South Texas Project Electric Generating Station P.O. Box 289 Wadsworth, Texas 77483

July 16, 2001
NOC-AE-01001140
STI: 31317309
FILE NO: Z18
ER 20010064
10CFR50.4(b)(5)
10CFR50 App E

STP NUCLEAR OPERATING COMPANY
Units 1 and 2
Docket Nos. STN 50-498; STN 50-499
Changes to Emergency Plan & Implementing Procedure

**Summary of Changes
STPEGS Emergency Plan
Interim Change Notice 19-3**

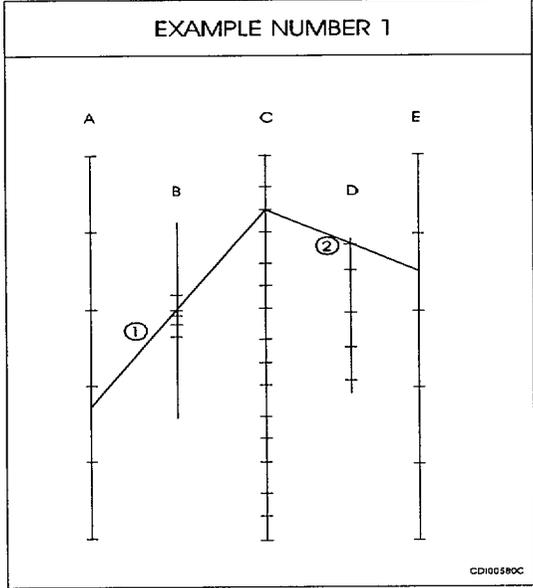
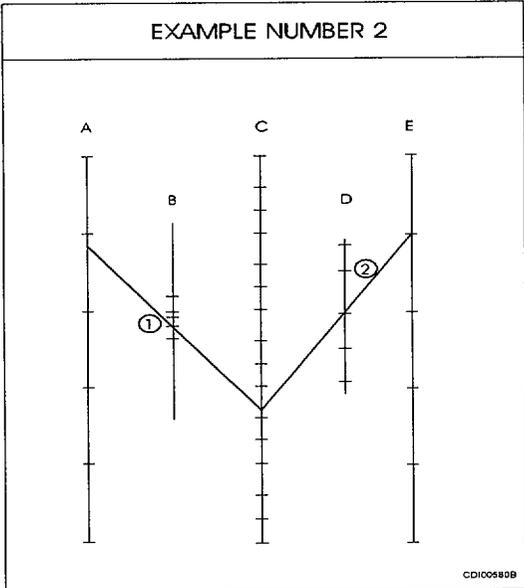
Changes to Revision 10	Reason
19.	Addendum 4, Page 15, provides example calculations using the containment leakage nomograph. Example 1 states that using the listed input values provided, the correct release rate should be 4.0 E+6 Vs 1.2 E+6 μ Ci/sec.	Change addresses CR 00-1818-6.

Find: RT-8050 reading of 2E+4 R/hr on A scale, and 10 hrs on B scale. Connect the two points with a straight line through C scale to find 2000 Ci/m³ (2000 μCi/cc). Connect the point at 2000 Ci/m³ to FSAR LEAK LIMIT (0.3% containment volume/day) on D scale. Extend line from C scale through D scale to read 4.0E+6 μCi/sec release rate.

Find: 1.1E+2 R/hr on A scale. Draw a line through 1 hour on B scale to find 5 Ci/m³ (5 μCi/cc) on C scale. Connect the point from C scale through 0.1 psi/hr on D scale to find 1E+6 μCi/sec release rate on E scale.
